### **Proposal for amendments to Annex 1 and 3**

#### **Revision**

#### **Submitted by the secretariat and the Chair**

1. This document consolidates comments as well as includes proposals for further amendments and/or text corrections provided by Experts, as well as from the secretariat to ECE/TRANS/WP.1/GE.2/2018/4/Rev.1 which suggested amendments to Annexes 1 and 3 of the Convention.
2. The comments and corrections are provided in the track changes mode.

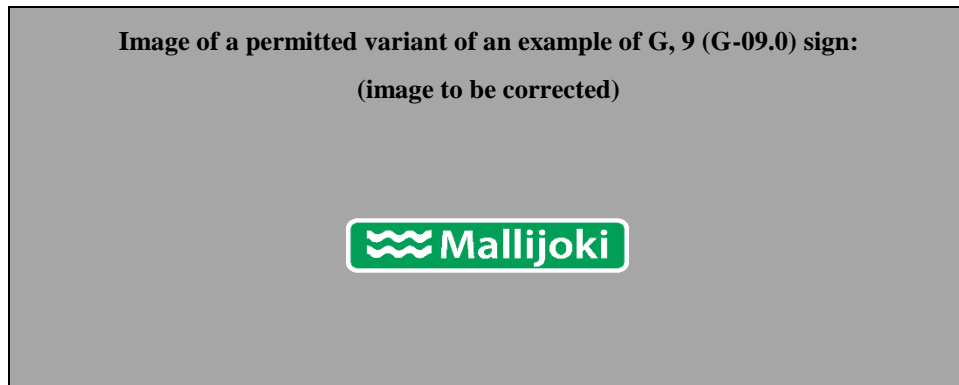
(image to be corrected)

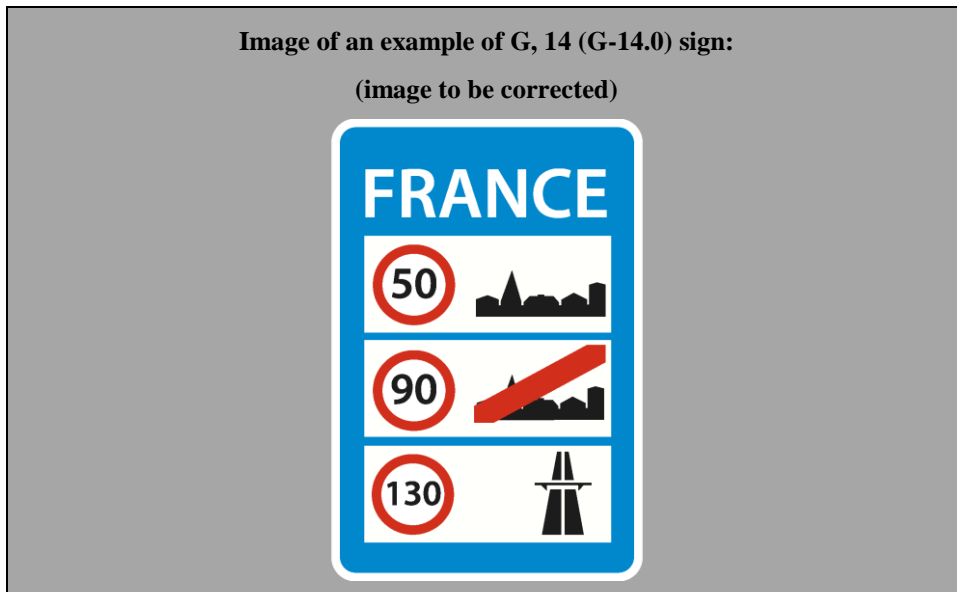
(image to be corrected)
